# DATAFILE BULLETIN

FILE UNDER: Receivers  
ER-41-C

BULLETIN NO: 1094-1

Equipment: 132—174 MHz MASTR Progress Line 5-watt receivers

FIGURE 1

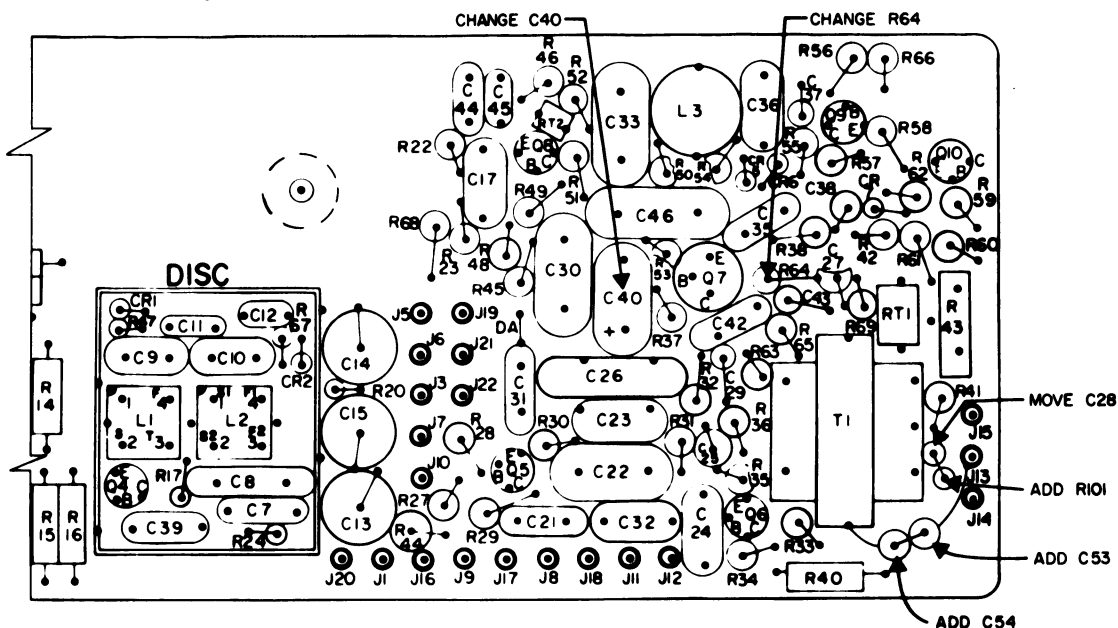
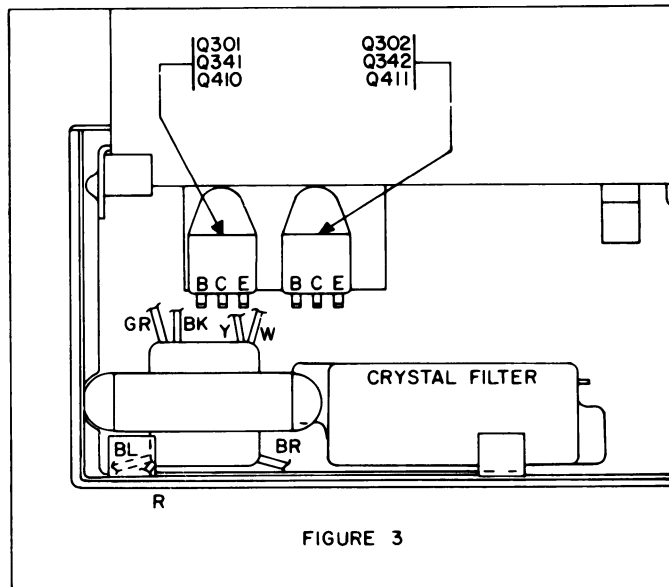
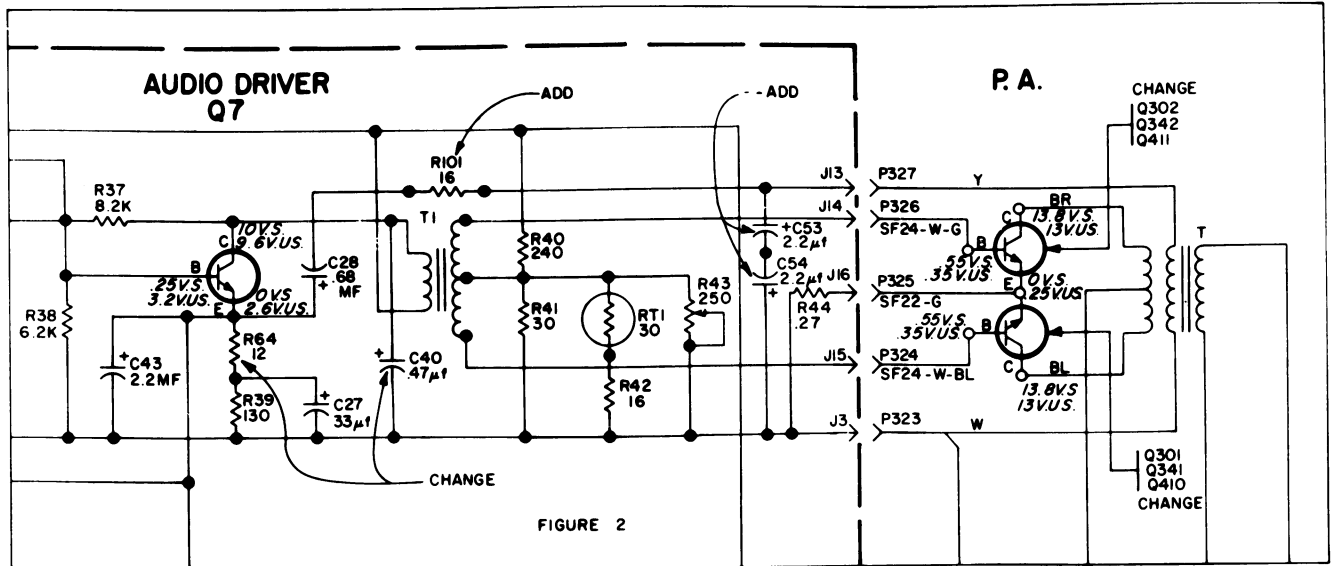
The 19A116203-P2 transistor can be used in place of the 19A115948-P1 but the following changes have to be made: (Refer to Figure 1, 2, & 3)

1. Change R64 from 18 ohms to 12 ohms.
2. Change C40 from 0.22  $\mu$ F to 0.47  $\mu$ F.
3. Add C53 and C54 (2.2  $\mu$ F) in series. Solder the can (Neg.) sides together. Connect the positive side of C53 to J13 pad and the positive side of C54 to system negative near T1.
4. Unsolder and carefully remove C28 (0.68  $\mu$ F). Solder the positive (+) side of C28 in the pad that connects to C43 & R64.
5. Solder one side of R101 (16 ohms) to the pad connecting J13. Solder the other side of R101 to the negative (-) side of C28.
6. Replace the two audio output transistors with 19A116203-P2. (see Fig. 3) Mount each transistor with a 19A116023-P2 insulator plate and a 19A116022-P1 bushing. Use silicon grease on both sides of the insulator plate.

The lead connections are different from the 19A115948-P1 transistor.

7. TEST PROCEDURE CHANGE: Turn the squelch control fully counterclockwise. Connect a milliammeter in series with the +12 volt lead at P443-11. With no signal in, adjust the PA bias adjust (R43) for a reading of approximately 20 milliamps.
